Planning Commission Regular Meeting

The Planning Commission considered an application for a Residential Review Permit and variance application for 202 Oak Street at their January 26, 2026 meeting. The item was continued to the February Planning Commission meeting. The attached Staff report accompanied the application. The applicant has submitted revised plans. Staff has revised the Staff Report to analyze the revised plans. Staff revisions to the Staff Report are in italics.

Excelsior Good Neighbor Guidelines PLAN Review

updated/revised 02/19/2026

② Rear Elevation
1/4" = 1'-0"

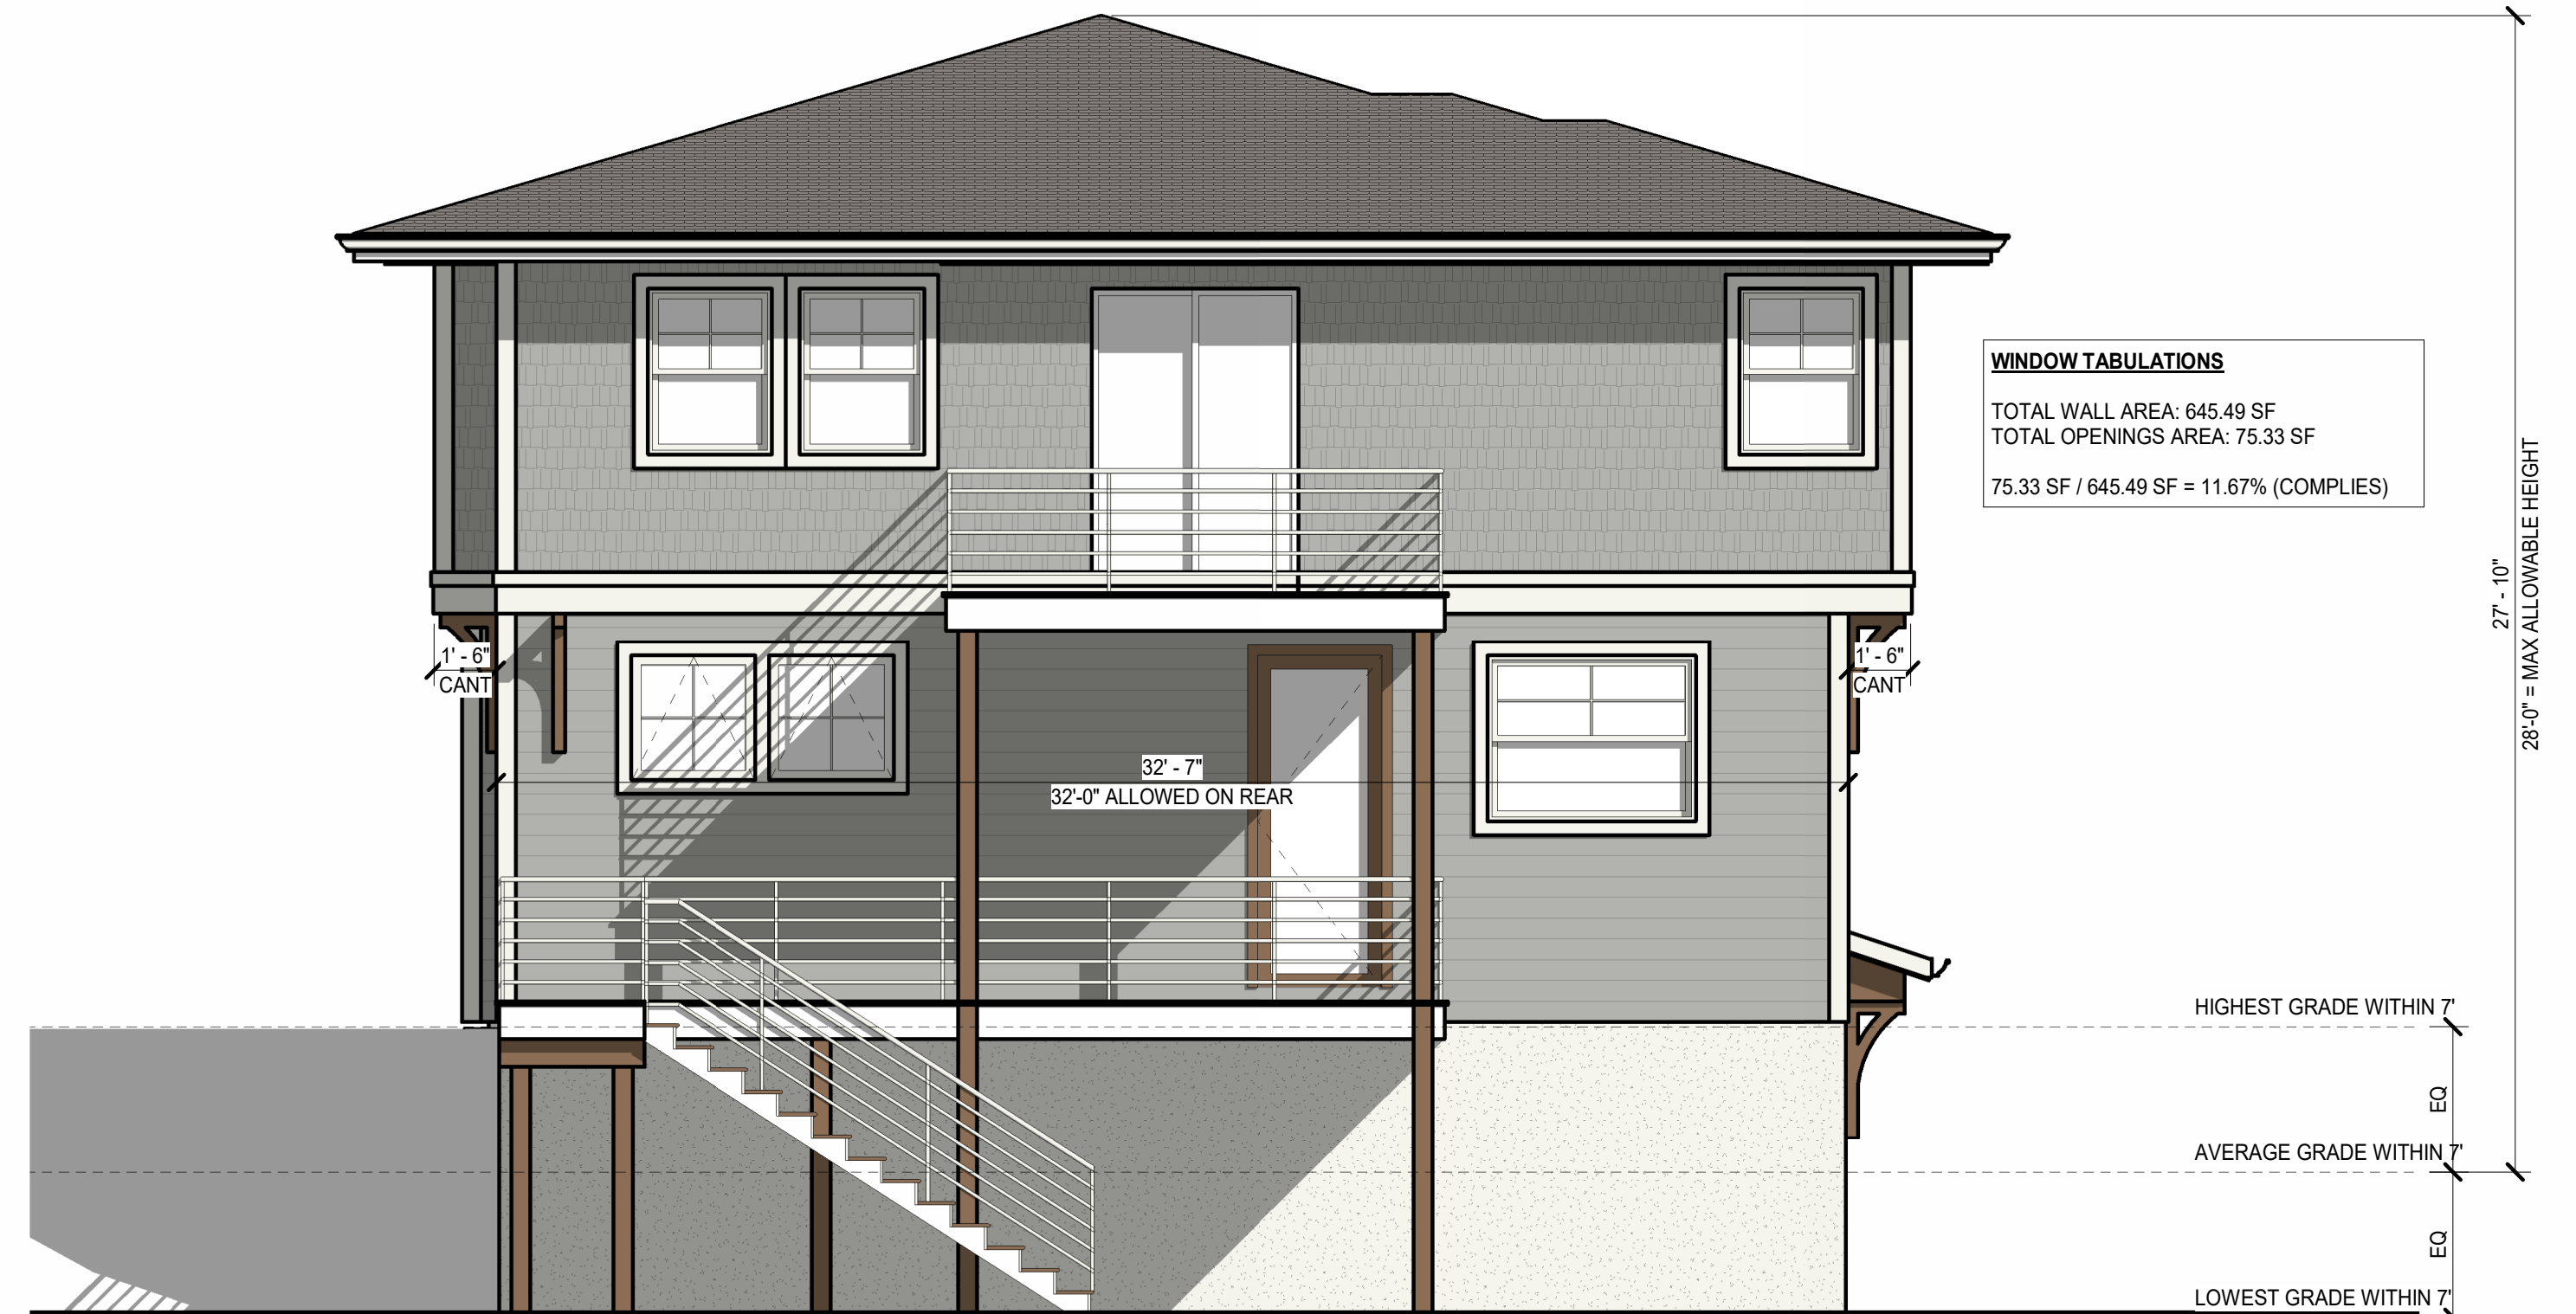
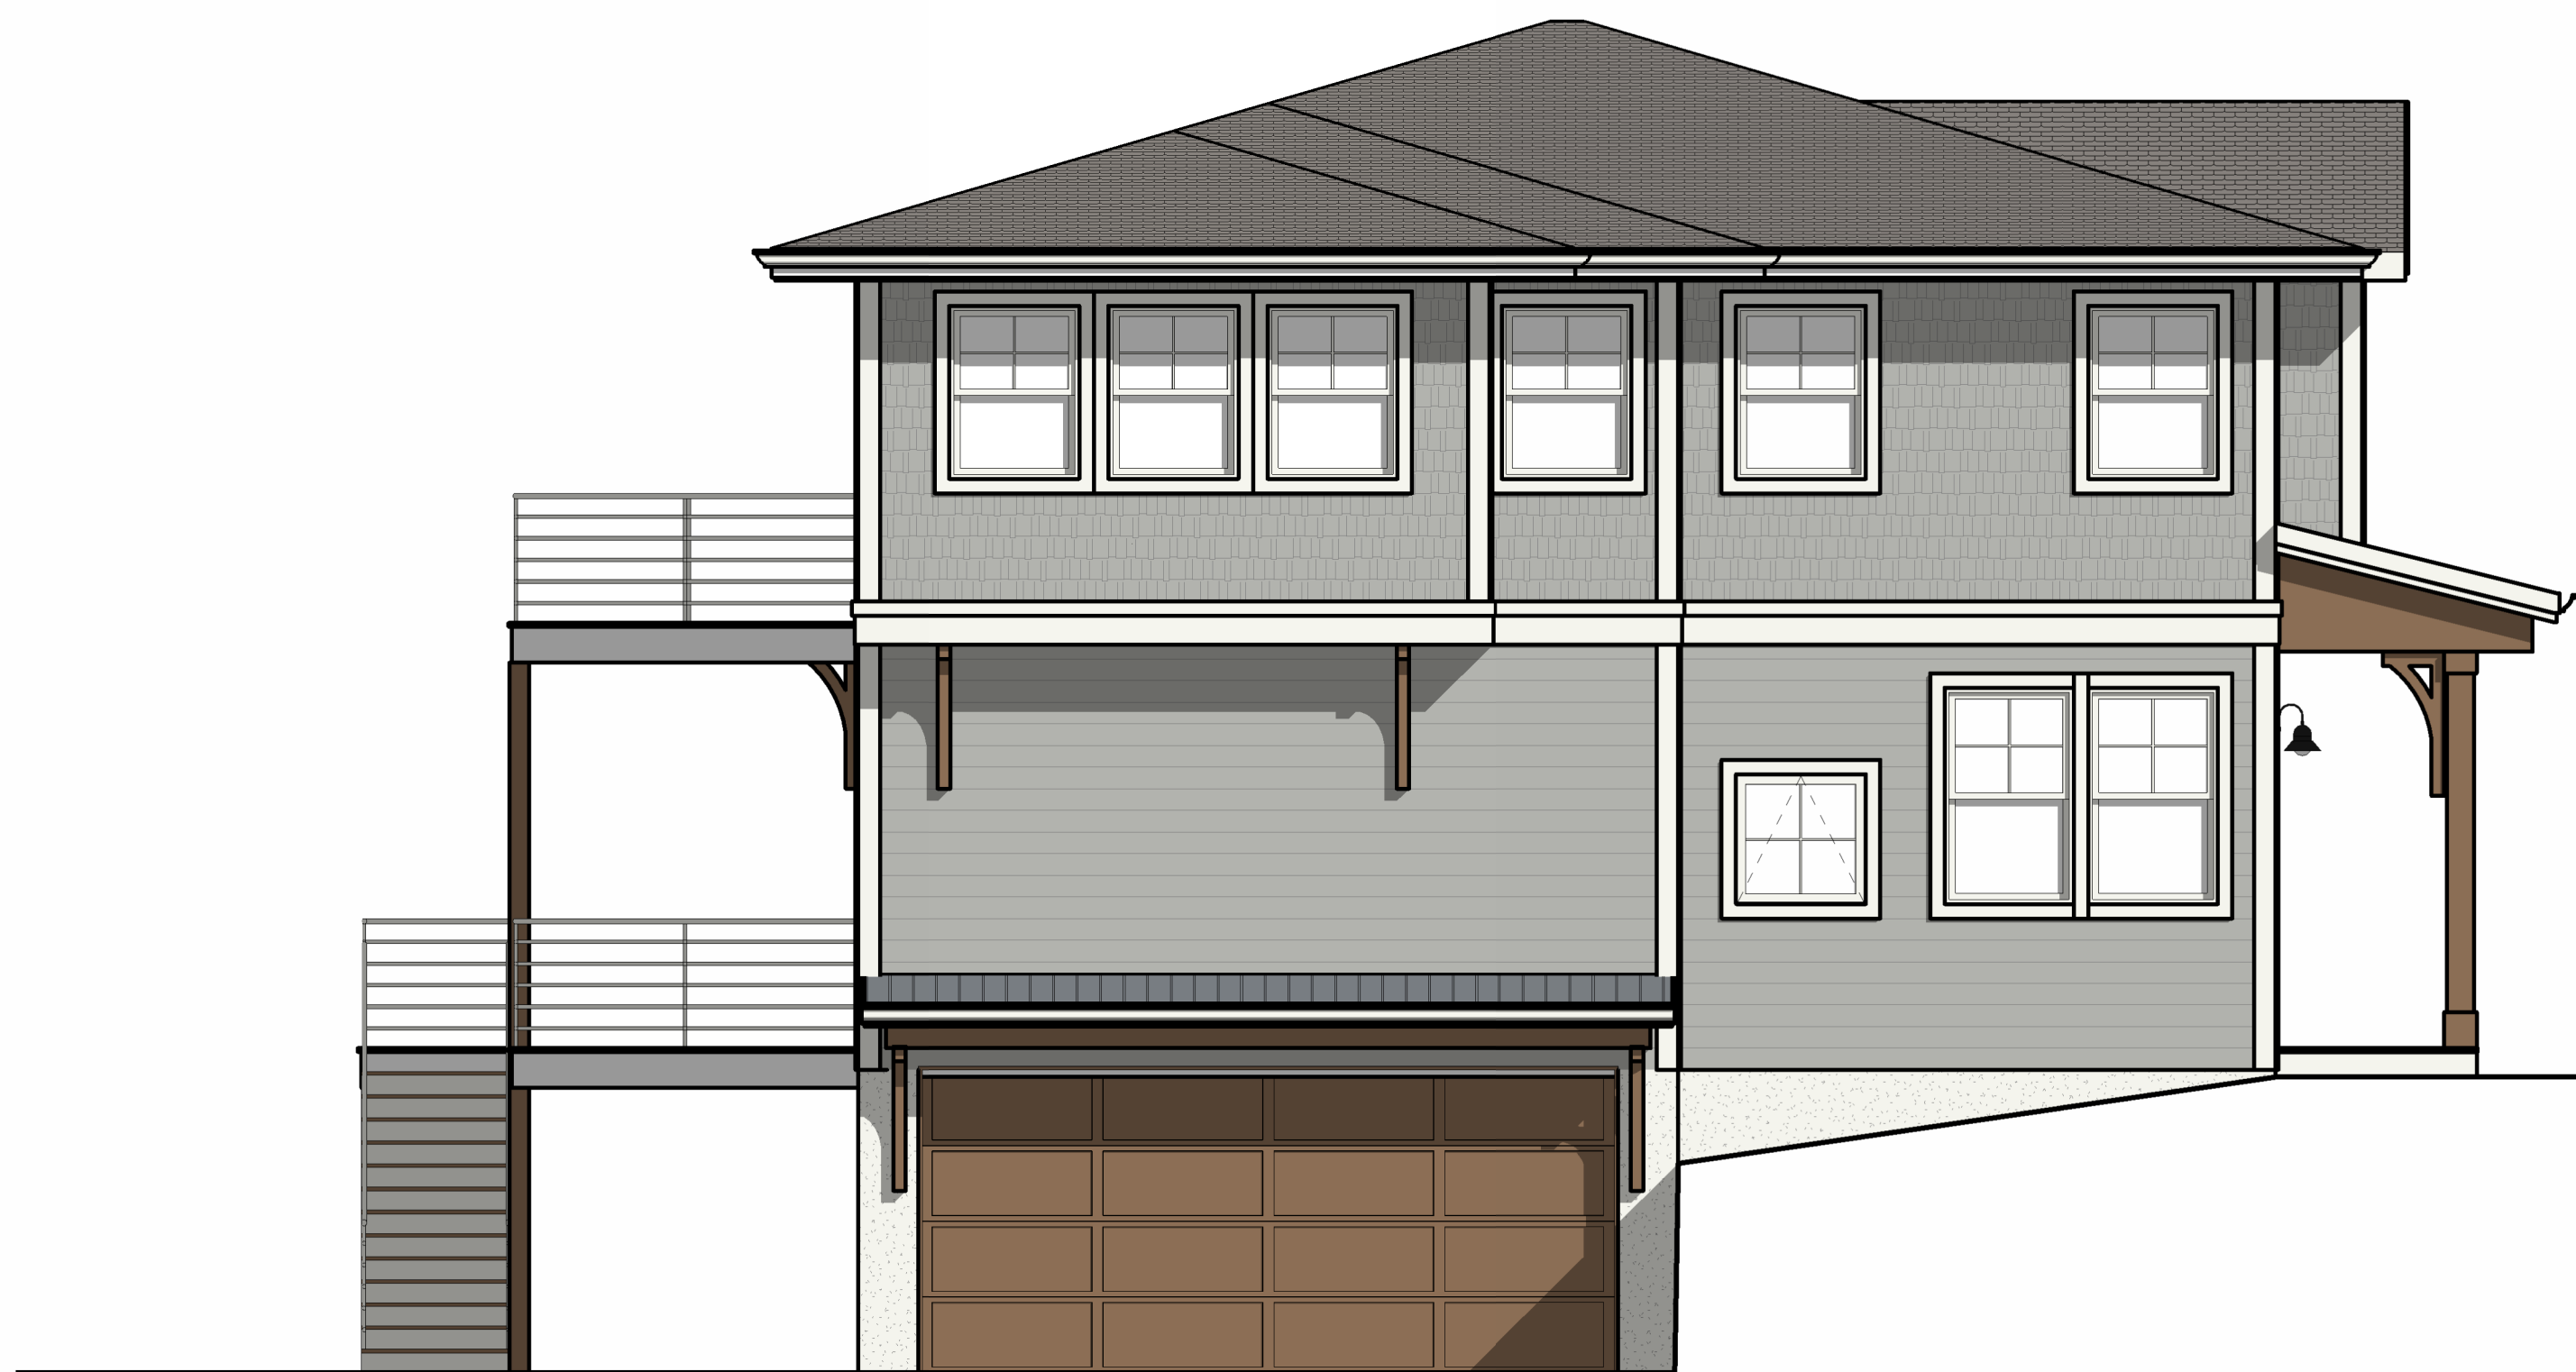
offsets or features to mitigate its three-story mass. *Revisions in this 02/26 submission show the addition of a 12-2 wide gable roof element with bracket supports at the rear elevation above the deck, which helps break up the roofline. Also, the entire second level at the rear has been cantilevered forward approximately 2-0, creating a shadowline and a significant break in the massing between the main and upper level. Both of these changes address concerns noted above. The Right-side elevation shows a full two-story cantilevered bump-out with gable roof added (previously was only second level bumpout/no roof gable) which helps break up the side elevation massing. Please refer to comparison diagram attached.*

OPTION A
FRONT PORCH

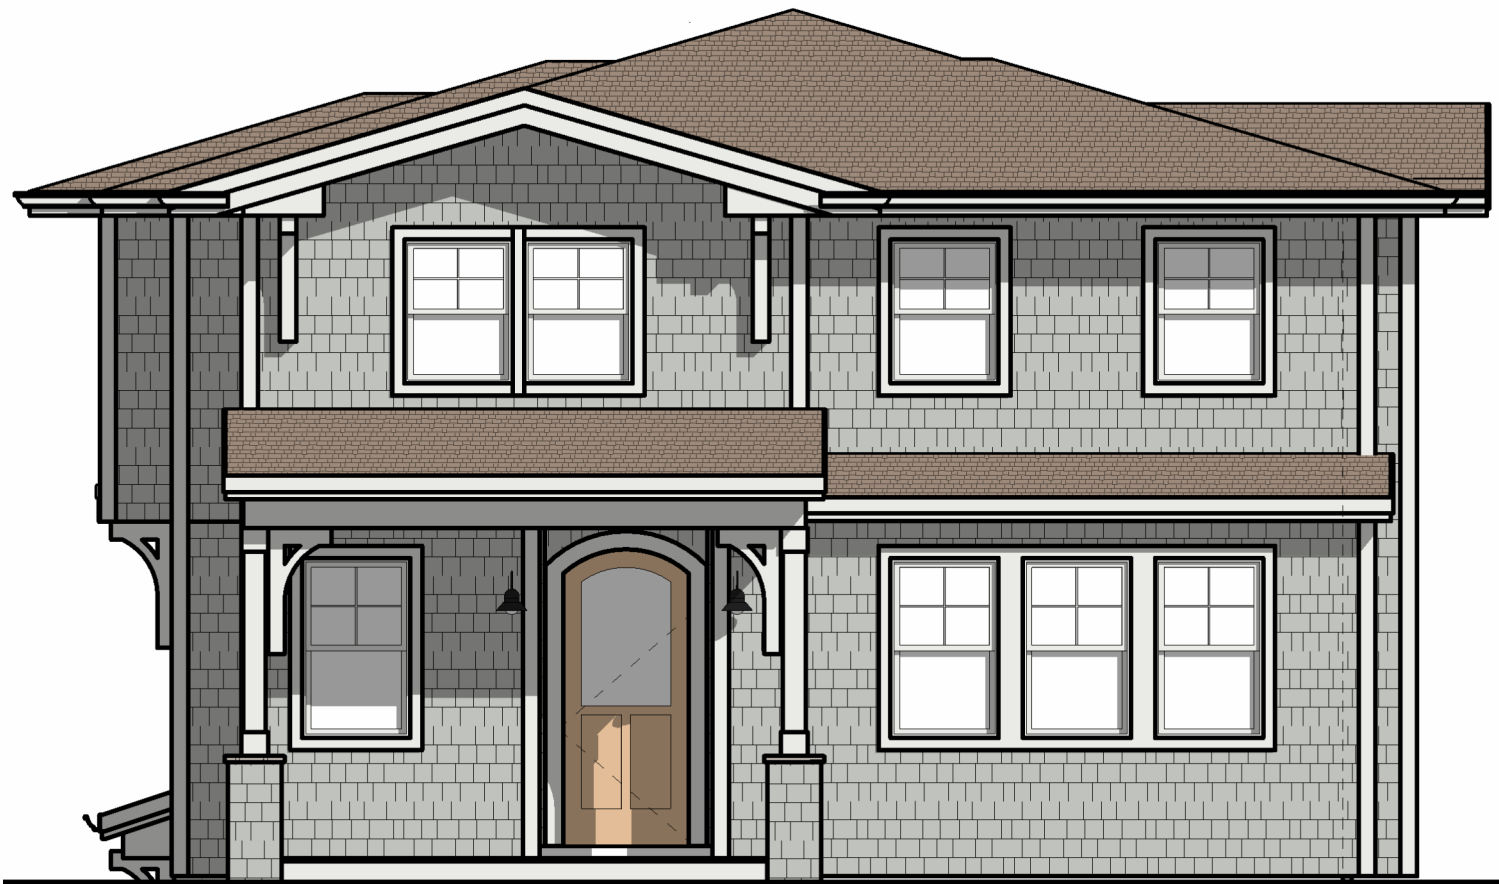
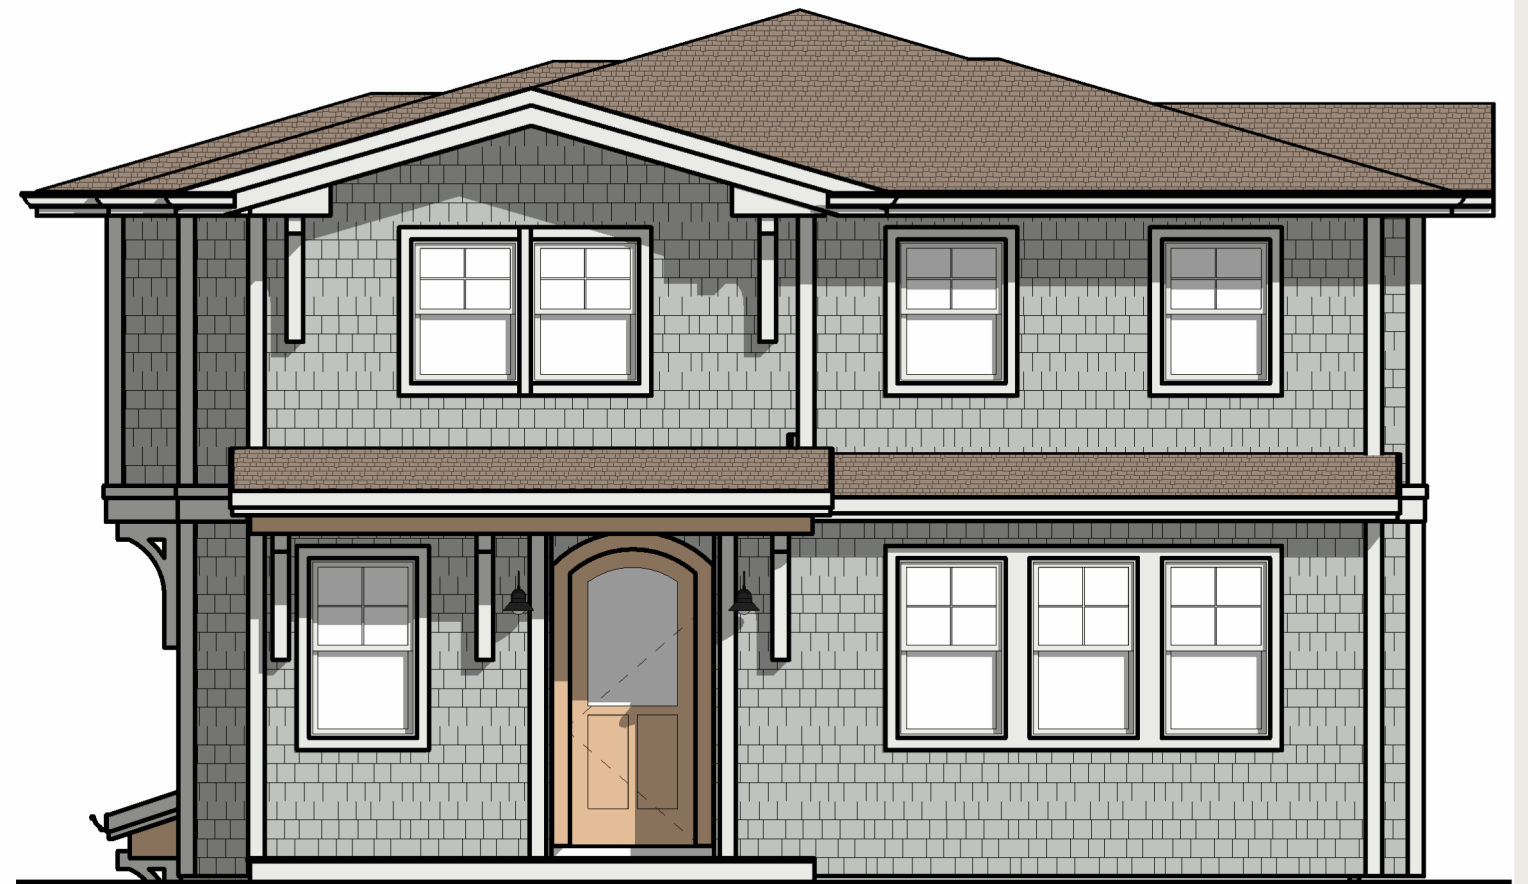
The proposed new 4-8 deep x 15-9 entrance porch frames a new entrance facing Oak Street (previous was an understated entrance facing the access driveway). This is an improvement to the public street face of the house and it helps to break up the two story massing, though it encroaches further on the front yard setback. *Revisions in this 02/26 submission show a simplified front porch that has the upper level pushed back to align with the wall plane below, which is an improvement. Applicant shows two possible options for porch, with and without columns. From a massing standpoint either appear acceptable, with a preference for Option A with columns.*
